**Re AUSTRALIAN MUSEUM – ALTERATIONS & ADDITIONS  
SSD 9452  
REVISED DESIGN STATEMENT**

In response to the feedback received from the Government Architect on the 18<sup>th</sup> December 2018 regarding SSD 9452 for the Australian Museum – Alterations & Additions the design team has completed a review of the feedback with the Museum to address the key points raised. The key changes following the SSD submission on the 11<sup>th</sup> August 2018 are detailed below. Please read these in conjunction with the updated drawings, reports and submissions table.

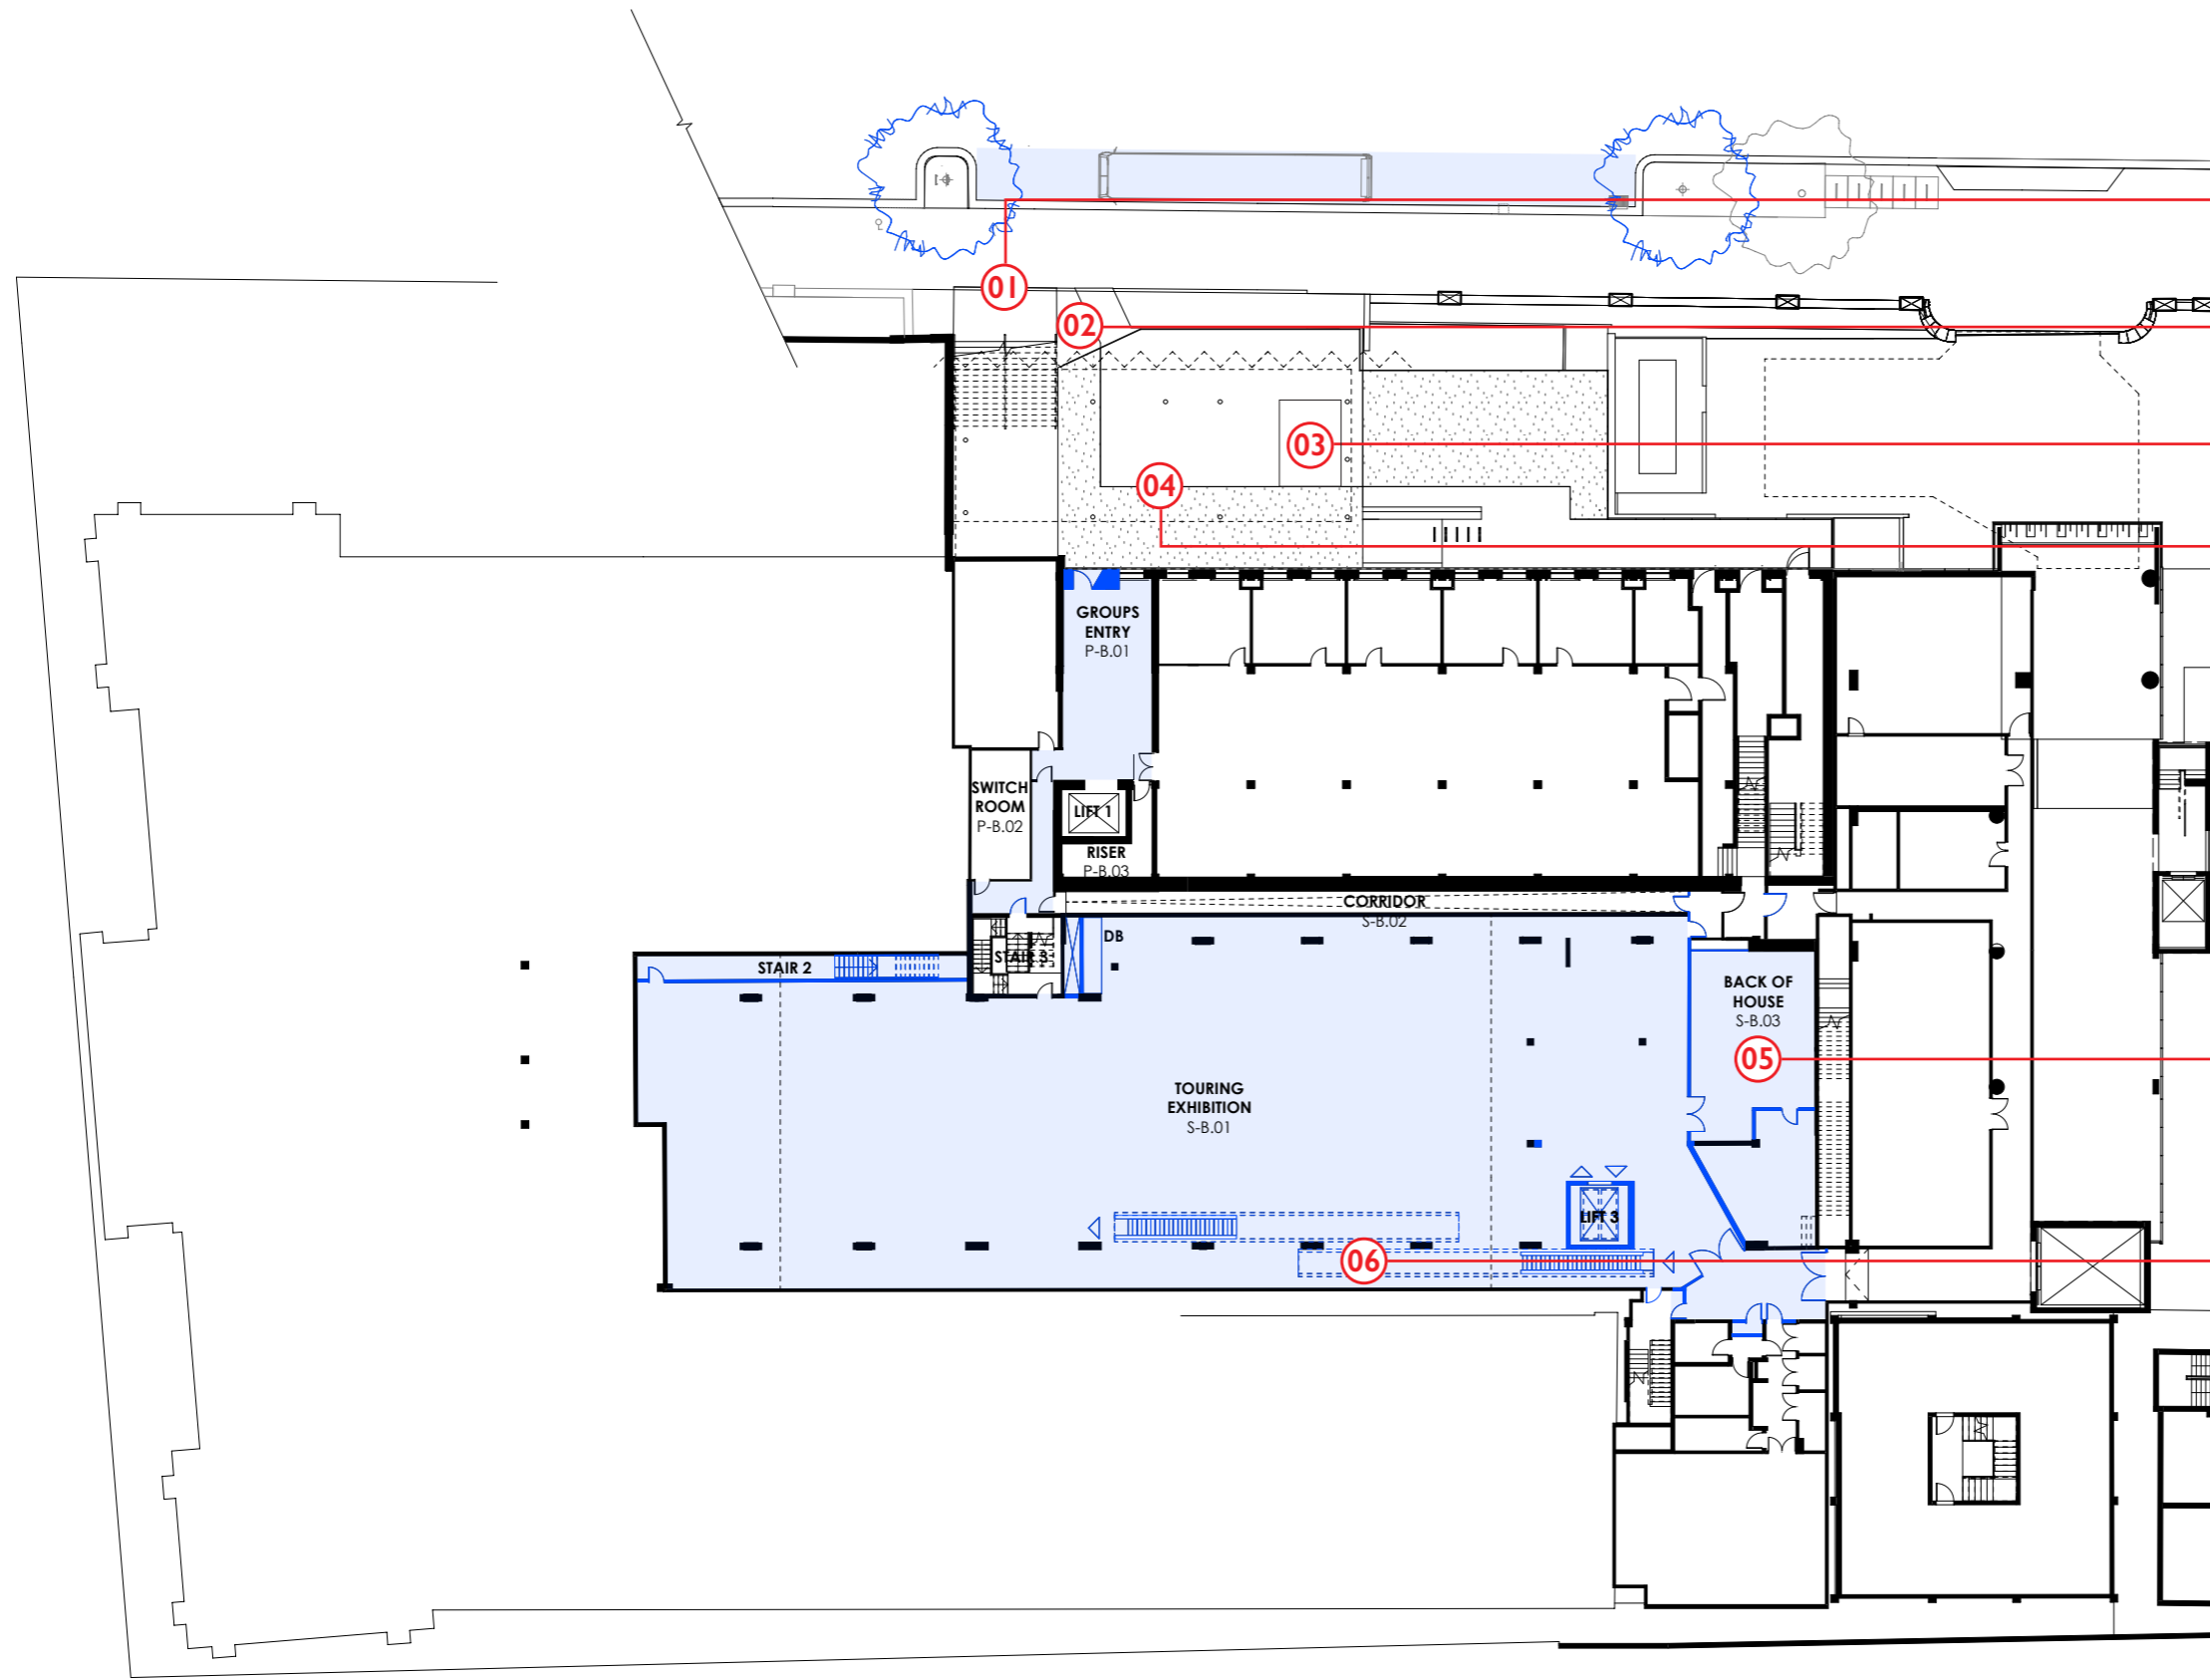
EXISTING WILLIAM STREET STAIRS  
RETAINED - NO NEW KIOSK

NEW ACCESS PATH FROM  
FOOTPATH TO GROUPS ENTRY

EXISTING COFFEE CART  
RELOCATED TO THE EAST

EXISTING SHELTERED  
GARDEN RETAINED

REPLANNED FIRE ROOM AND  
BACK OF HOUSE TO IMPROVE  
LOADING

RELOCATED ESCALATORS +  
REDUCED VOID TO INCREASE  
HEART SIZE

# BASEMENT

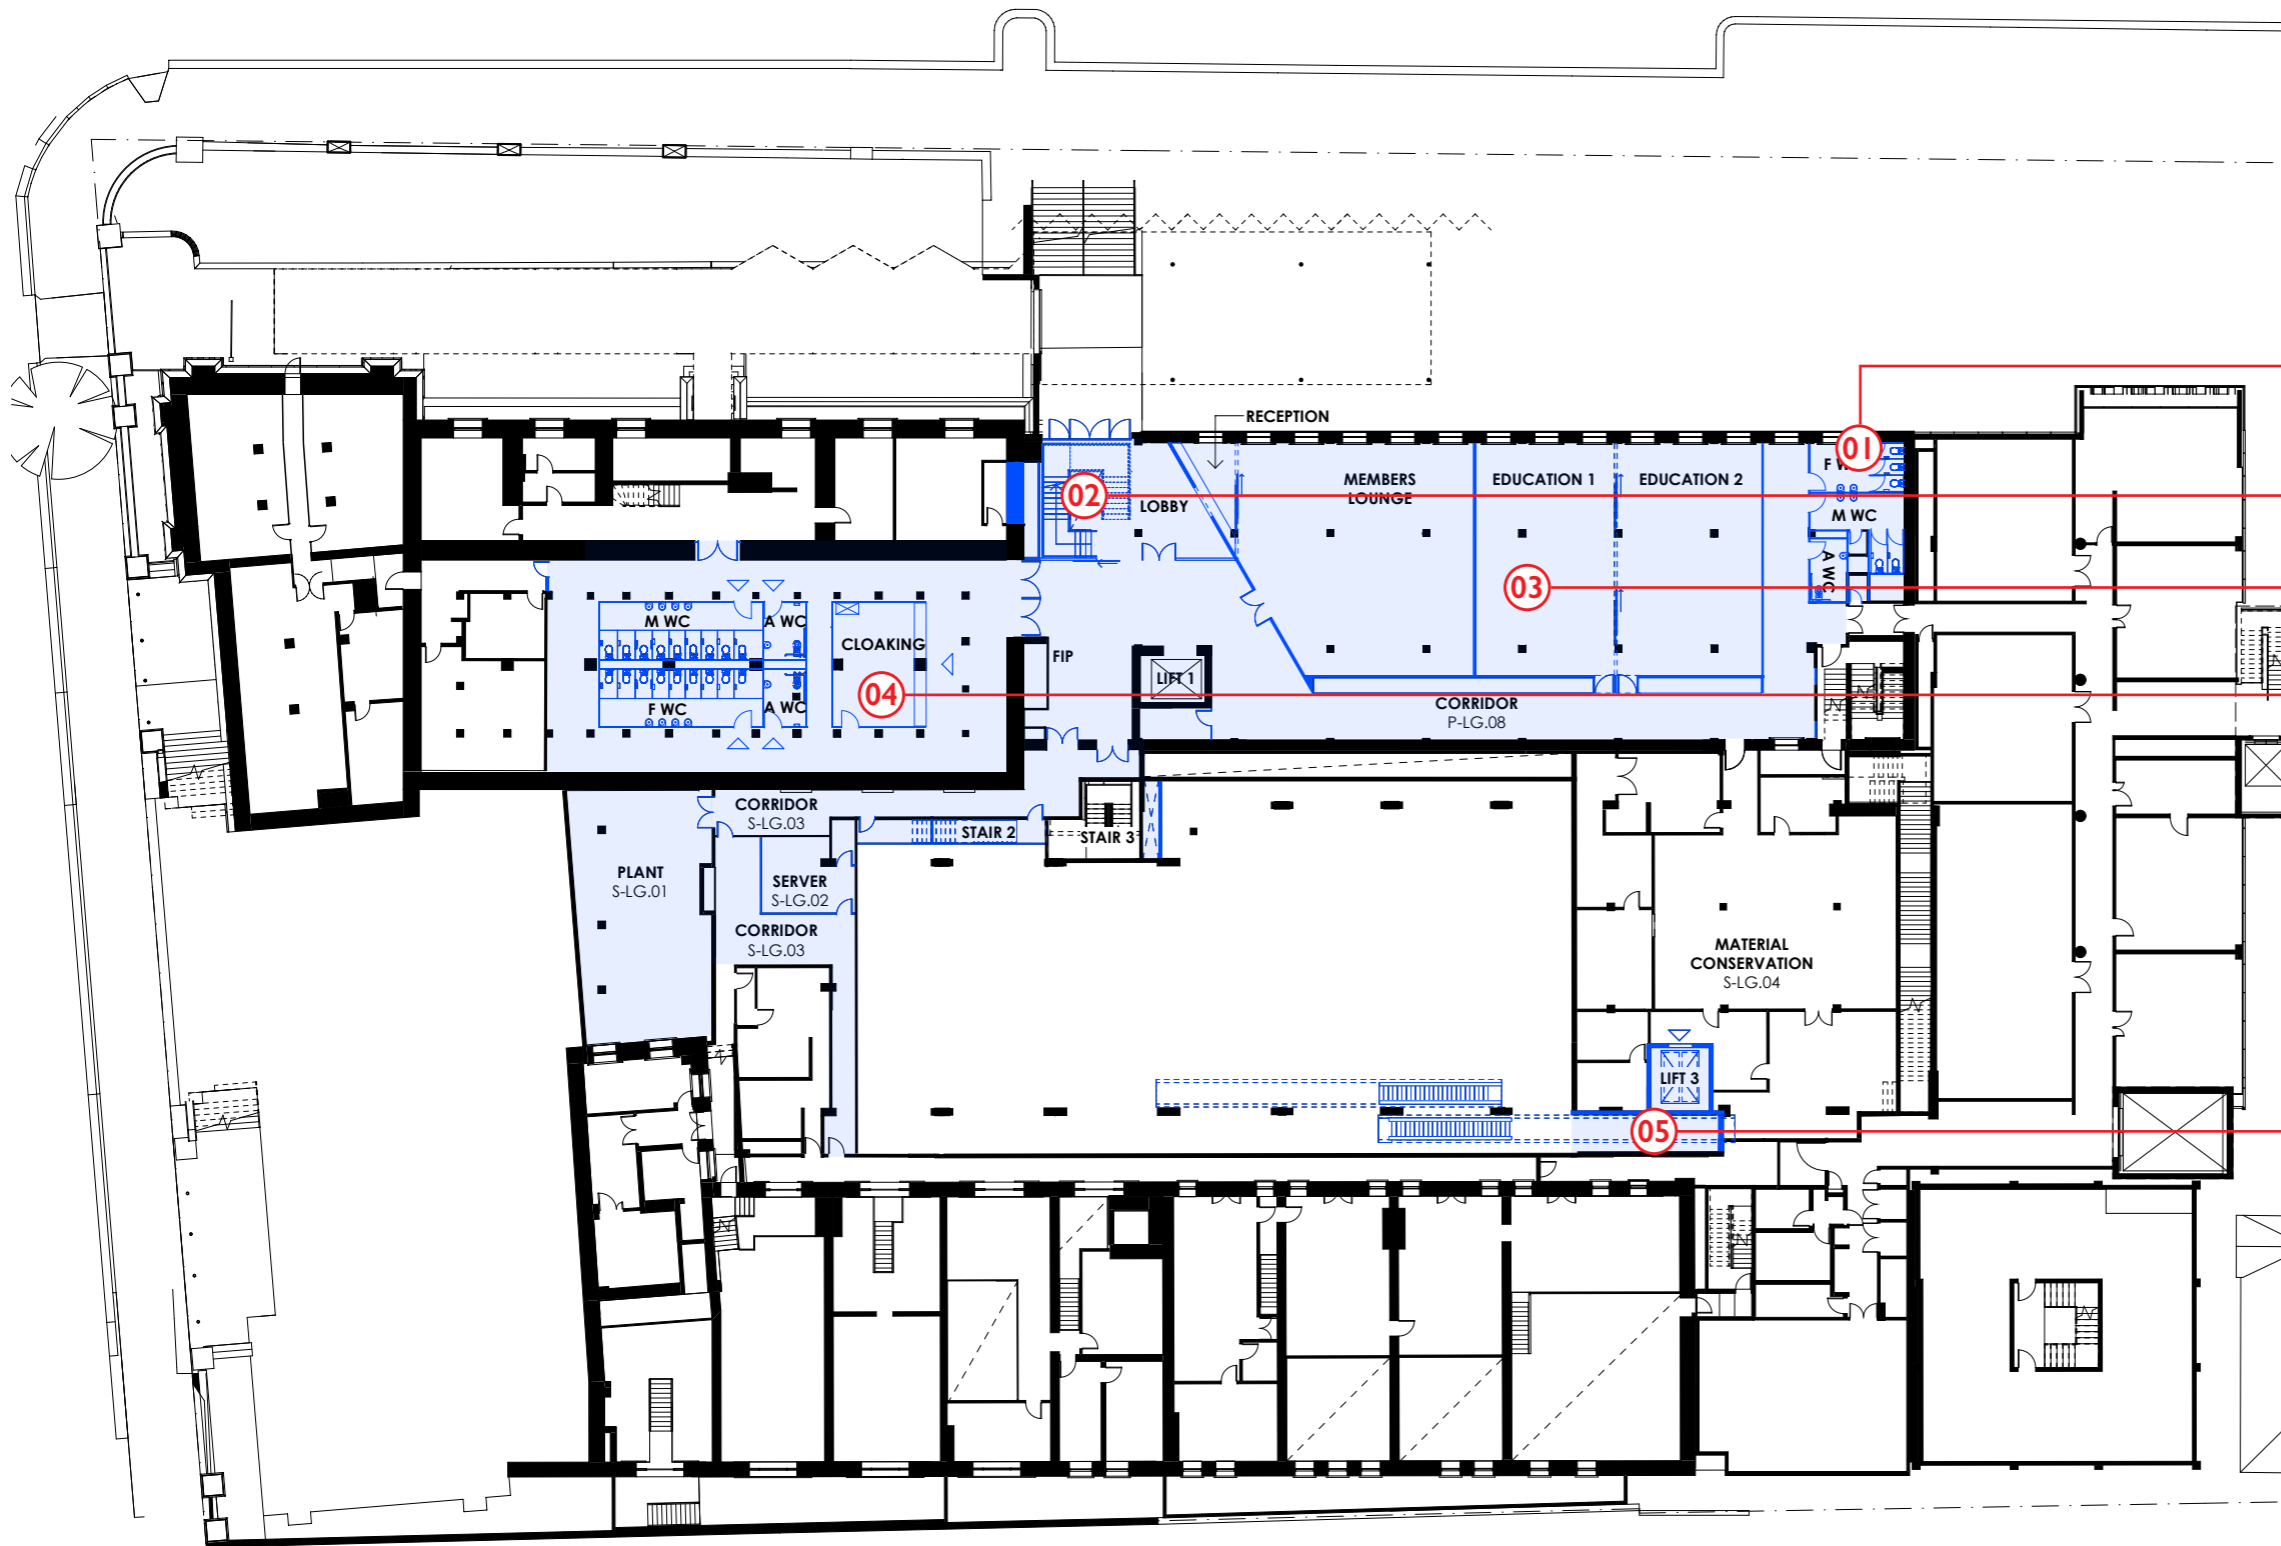
- 01 DEDICATED GROUPS AMENITIES
- 02 NEW STAIR RELOCATED TO GLAZED LINK
- 03 MORE GENEROUS MEMBERS LOUNGE + EDUCATION SPACES
- 04 AMENITIES AND CLOAKING RELOCATED TO LOWER GROUND LEVEL
- 05 ADDITIONAL DEMOLITION TO MATERIALS CONSERVATION FOR ESCALATOR

# LOWER GROUND

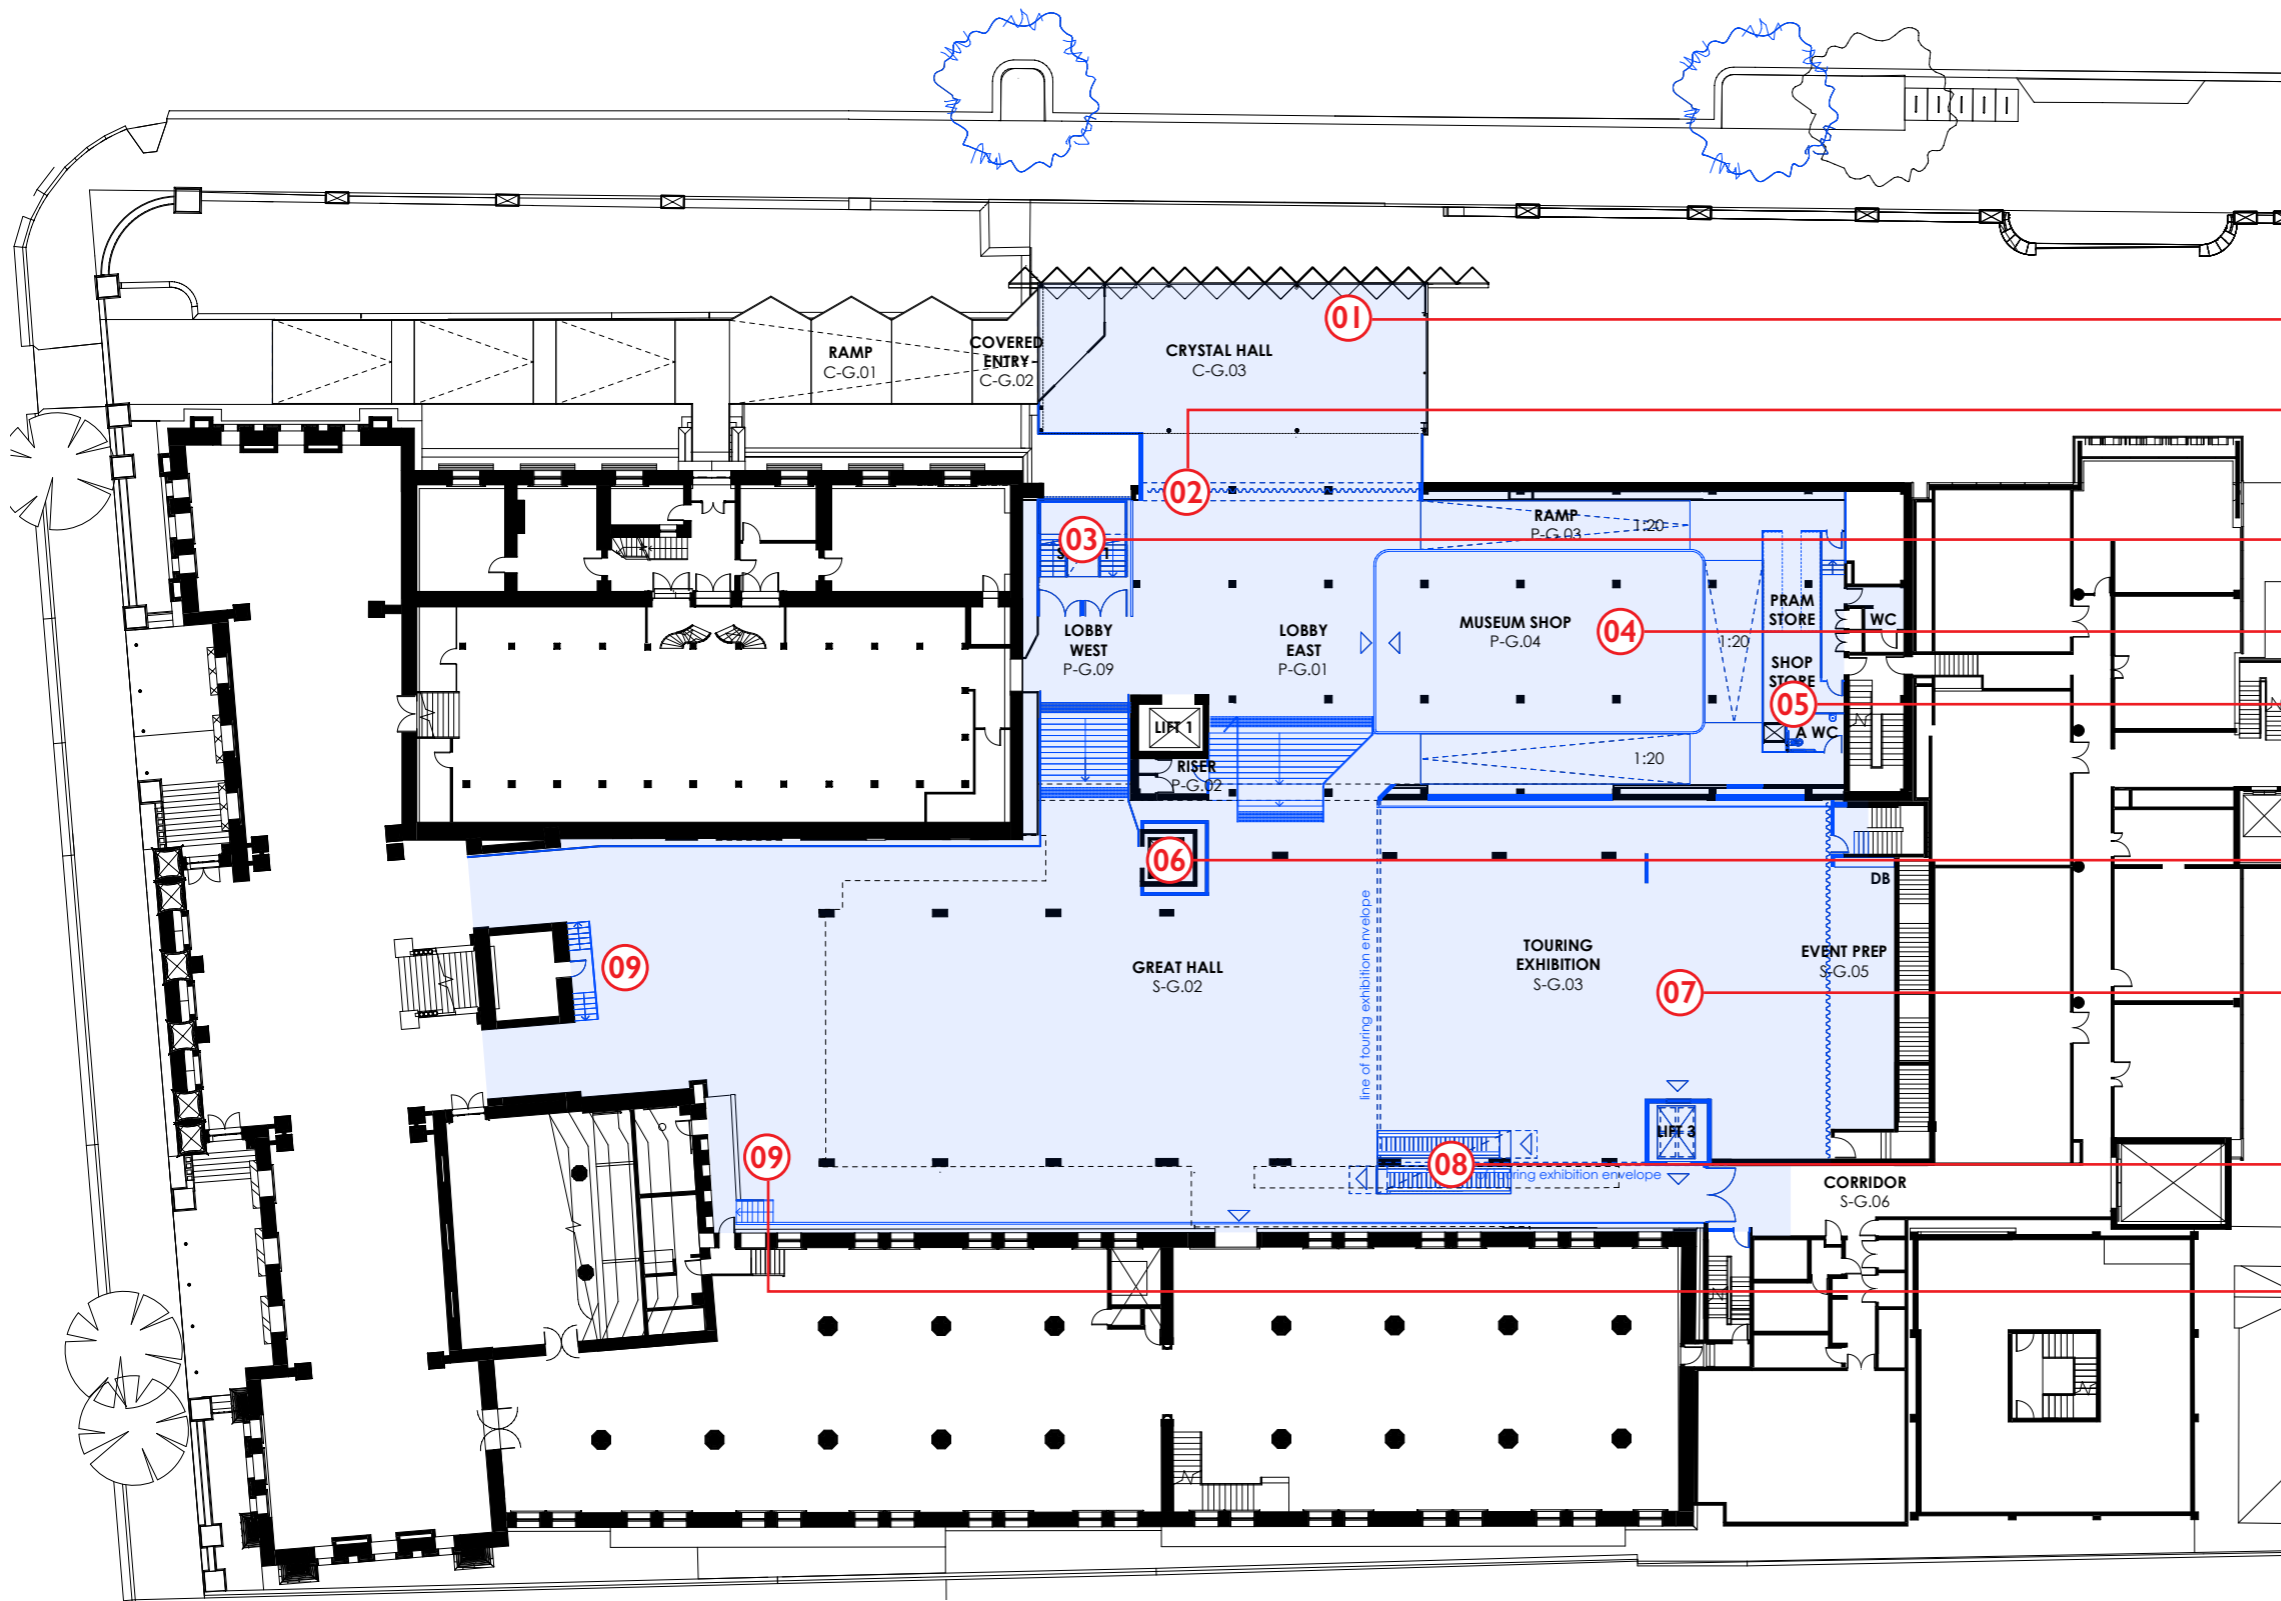
- CRYSTAL HALL REMAINS AT CURRENT LENGTH
- INCREASED ENTRY OPENING
- NEW STAIR RELOCATED TO GLAZED LINK
- INCREASED SHOP LENGTH
- PUBLIC AMENITIES + MORE GENEROUS CLOAKING RELOCATED TO LOWER GROUND
- LIFT ALTERED TO STOP AT NEW HEART LEVEL
- RAISED HEART FLOOR - REMOVES RAMPS MAKING WIDTH OF STILL ADDITION ACCESSIBLE
- RELOCATED ESCALATORS + REDUCED VOID TO INCREASE HEART SIZE
- NEW ACCESS TO EXISTING TOILETS + STORE
